Proposal #17: 2652-05-70

Milwaukee River Bridge B40-548

This is Addendum No. 01, which provides for the following:

ADDENDUM NO. 01 2652-05-70 February 6, 2025

Revised Sheet 62 February 6, 2025

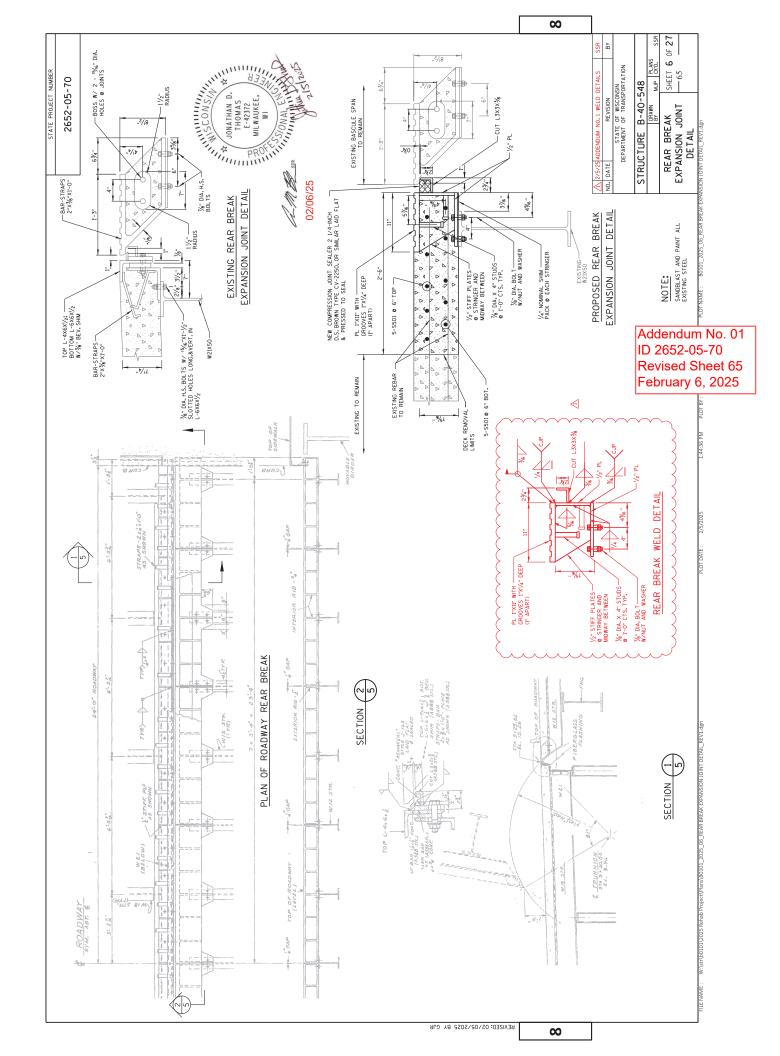
Revised Plan Sheets				
Plan Sheet	Plan Sheet Title (brief description of changes to sheet)			
62	Total Estimated Quantities- The SF quantity of the Fiberglass Sidewalk Floor Plates in the plan revised.			
65	Rear Brake Expansion Joint- The rear brake weld detail added to the plan. The rear brake should contain no more than 4 segments.
